STAFF HEARING OFFICER STAFF REPORT

REPORT DATE: April 21, 2016
AGENDA DATE: April 27, 2016
PROJECT ADDRESS: 711 North Milpas Street (MST2015-00561)
TO: Susan Reardon, Senior Planner, Staff Hearing Officer
FROM: Planning Division, (805) 564-5470, extension 4549
 Beatriz Gularte, Senior Planner *BEG*
 Andrew Bermond, AICP, Project Planner *ARB*

Milpas Mixed-Use Development Milpas & Ortega Streets, Santa Barbara, CA

Exterior Elevations

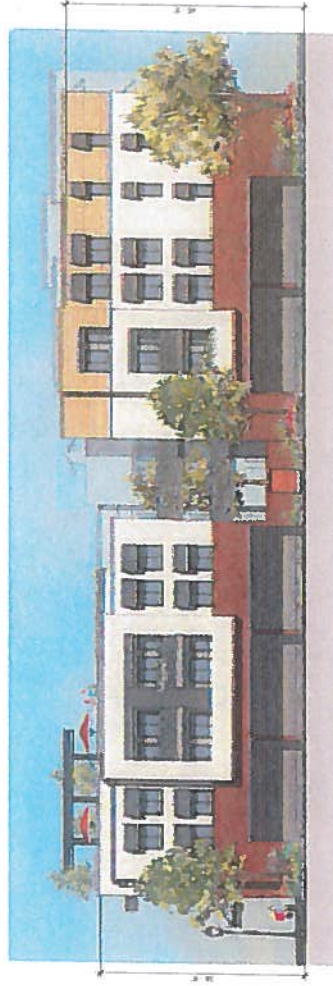
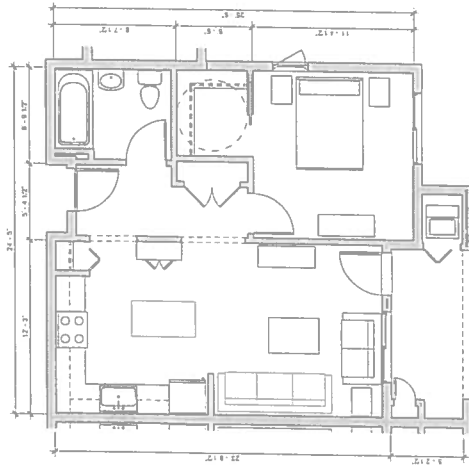
- Appreciates the results and setbacks from the interior property lines, the courtyard, and the result of much more livable units.
- Agrees with comments made about architectural design. The elevations on the back and on the side shown on the plans are much harsher than the Ortega and Milpas Street elevations.
- Agrees with Leslie Colasse that “the east side deserves projects whose architecture is compatible with the amazing buildings that it is home to”. The ABR is charged with having buildings that are compatible with Santa Barbara’s historic heritage and she would like to see this reflected in the design. This does not mean it has to be Spanish Style architecture. It can add some elements.

- On the right track. The only negative comment is to look at the backside of building, the white parts, and blend them more to the mountain scape in the back.
